Granite Knolls Solar

To: Yorktown Planning Board

From: Yorktown Tree Conservation Advisory Commission (TCAC)

Re: Proposed solar facility Granite Knolls Park

LANDSCAPING/TREE MITIGATION SITE PLAN

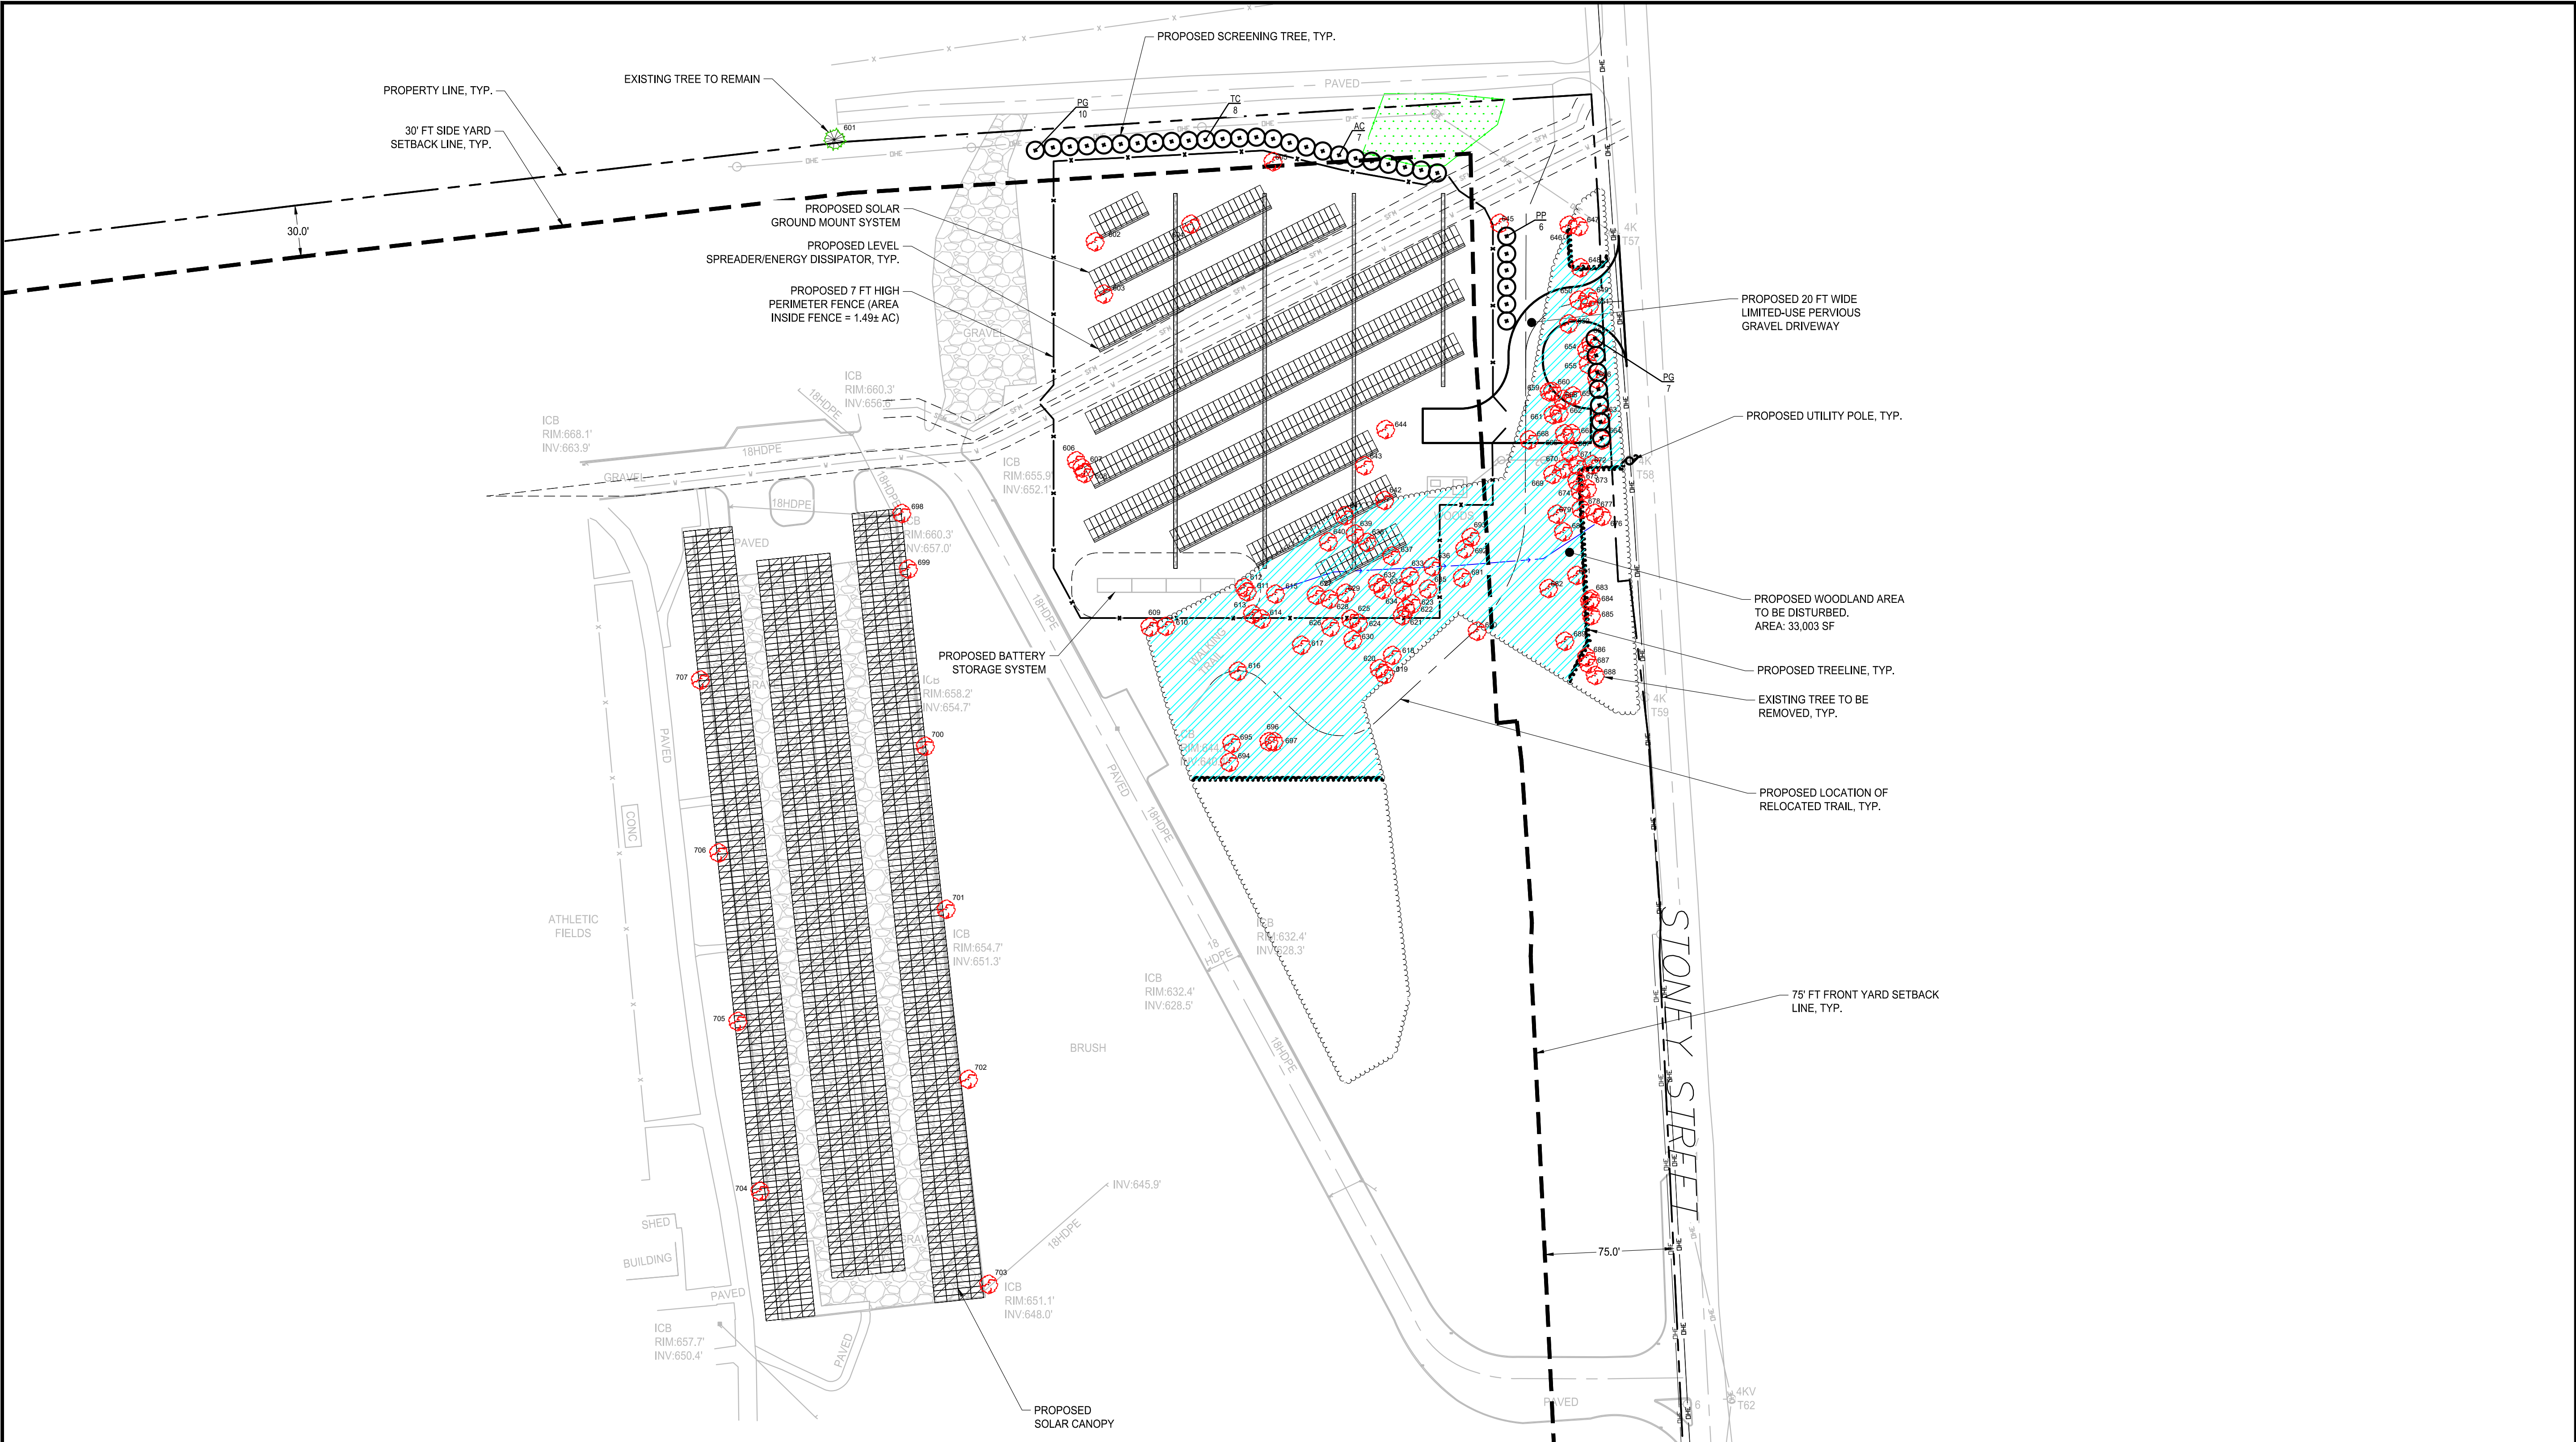
- The Engineer has still not provided a proper mitigation plan. The proposed mitigation plan consists of planting 38 evergreen trees which function as screening. This does not qualify as a mitigation plan. Chapter 300-81.4.F.(3)(g) states that "Landscape screening and buffering shall be required." Furthermore, during the PB's work session of 24 January 2022, related to the Foothill Street solar project, the PB's lawyer, James W. Glatthaar, Esq., stated that screening plantings do not qualify as replacement trees because a screening plan is required by the solar law.

- Native trees, deciduous and evergreen should be grouped in clusters to provide better screening.
- An erosion prevention plan post construction should be submitted.
- Pollinator Friendly Solar Scorecards are being utilized in many states as an entomologist approved standard, within managed landscapes of solar facilities, to achieve best practices, when planting for pollinators. The board suggests that the applicant review that standards as applied in the following Vermont scorecard:
https://2lwej44565rn2mmjlk31pmwq-wpengine.netdna-ssl.com/wp-content/uploads/2019/12/Vermont-Pollinator_Solar_Scorecard_FORM.pdf

In accordance with the Town’s Tree Law, we are proposing a combination of two of the mitigation measures outline in section 270-10(D)(4) of the tree ordinance. First, we are proposing planting 38 new evergreen trees. Second, we are proposing a payment to the Tree Bank Fund for the balance of our mitigation obligations. Per Town code section 270-10(4)(f), payment of \$100 per protected tree removed as well as \$300 per 5,000 square feet of Protected woodland disturbed will made to the Tree bank Fund.

The Landscaping Plan for the project involves 38 new evergreen trees across selected parts of the property. This includes the front yard along Stoney Street and along the entrance driveway north of the project location. All the trees planted will be evergreen species in order to provide year-round coverage, including White Fir, White Spruce, Canadian Hemlock and Colorado Spruce. These trees have installed heights ranging from 6 to 8 feet high and mature sizes ranging from 50 to 75 feet.
